# Access Compliance Report

## Public Rights-of-Way

Intersection ID: 2857	Main Street: BEAUVISTA_DR	Cross Street: BEECH_COVE_LN	Location: NE
ADA ID: A8E994321982	Ramp Type: PerpDiag	Initial Pass/Fail: Fail	Overall Compliance: No
Severity Score: 33.75			
Codes/Mitigation Info/Possible Solution		Field Measurements/Component Compliance

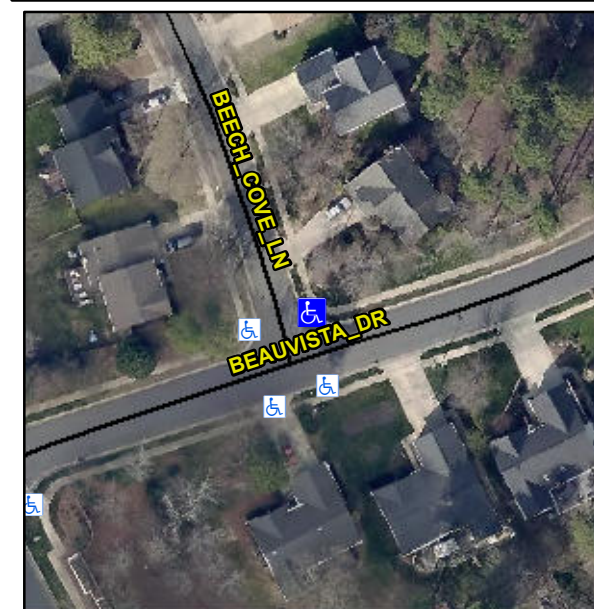
**Not Found, R304.5.1, R304.5.3**

Compliance	Description	Data	Compliance	Description	Data
N/A	Ramp Length (in)	46.0	Yes	Ramp Slope (%)	5.8
No	Ramp Width (in)	39.0	No	Ramp XSlope (%)	10.6
N/A	Flare Type LT	N/A	N/A	Flare Type RT	N/A
N/A	Flare Slope LT (%)	N/A	N/A	Flare Slope RT (%)	N/A
N/A	Flare Traversable LT?	N/A	N/A	Flare Traversable RT?	N/A
N/A	Landing Length (in)	N/A	N/A	DWS Provided?	N/A
N/A	Landing Width (in)	N/A	N/A	DWS Contrast?	N/A
N/A	Landing Slope (%)	N/A	N/A	DWS Length (in)	N/A
N/A	Landing X Slope (%)	N/A	N/A	DWS Full Width?	N/A
N/A	Landing Curb? (Y/N)	N/A	N/A	DWS Offset (in)	N/A
N/A	Shared Landing?	N/A			
N/A	Gutter Ponding?	N/A	N/A	Gutter Slope (%)	N/A
N/A	Gutter Lip Ht (in)	N/A	N/A	Gutter X Slope (%)	N/A
N/A	Painted X Walk1?	No	N/A	Painted X Walk2?	No
	X Walk 1 Direction	To W		X Walk 2 Direction	To S
N/A	X Walk 1 Width (in)	N/A	N/A	X Walk 2 Width (in)	N/A
	X Walk 1 Slope (%)	2.3		X Walk 2 Slope (%)	9.0
	X Walk 1 X Slope (%)	4.3		X Walk 2 X Slope (%)	6.4

**Remove & Replace Curb Ramp With Two New Directional Ramps or Equivalent.**
